**SUNDRY NOTICES AND REPORTS ON WELLS**  
*Do not use this form for proposals to drill or to re-enter an abandoned well. Use form 3160-3 (APD) for such proposals.*

1. Type of Well <input checked="" type="checkbox"/> Oil Well <input type="checkbox"/> Gas Well <input type="checkbox"/> Other		8. Well Name and No. TODD 22N FED 14
2. Name of Operator DEVON ENERGY PRODUCTION CO LP Contact: ERIN WORKMAN Email: ERIN.WORKMAN@DVN.COM		9. API Well No. 30-015-32734-00-S1
3a. Address 333 WEST SHERIDAN AVE OKLAHOMA CITY, OK 73102	3b. Phone No. (include area code) Ph: 405-552-7970.	10. Field and Pool, or Exploratory INGLE WELLS-DELAWARE
4. Location of Well (Footage, Sec., T., R., M., or Survey Description) Sec 22 T23S R31E SESW 660FSL.1980FWL		11. County or Parish, and State EDDY COUNTY, NM

**Todd 22N Fed 14  
30-015-32734  
Devon Energy Production Co., LP  
November 28, 2014  
Conditions of Approval**

**PROPOSED SCHEMATIC**

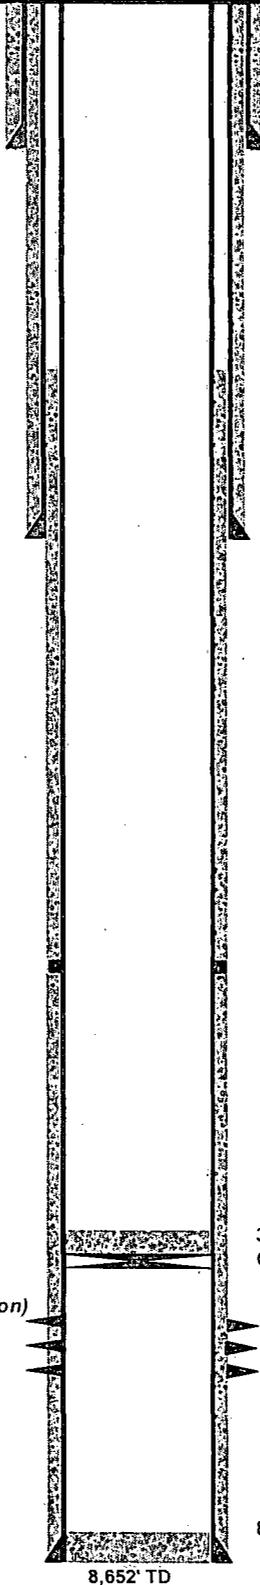
- 1. Operator shall place a balanced class H cement plug from 8,300'- 8,100' to seal the top of the Bone Spring formation. WOC and tag.**
- 2. Must conduct a casing integrity test to 1500 psi or 0.22 psi per foot whichever is greater. If casing test fails, submit remediation or P&A plan to the BLM.**
- 3. If producing zone is found unproductive, operator shall place CIBP at 6,820' and operator may place 35' class C cement on top in order to recomplete in the Brushy and/or Cherry Canyon. Tag required.**

**NOTE: Operator must add 25sx class C cement to the top of the CIBP prior to abandoning the Delaware zone.**
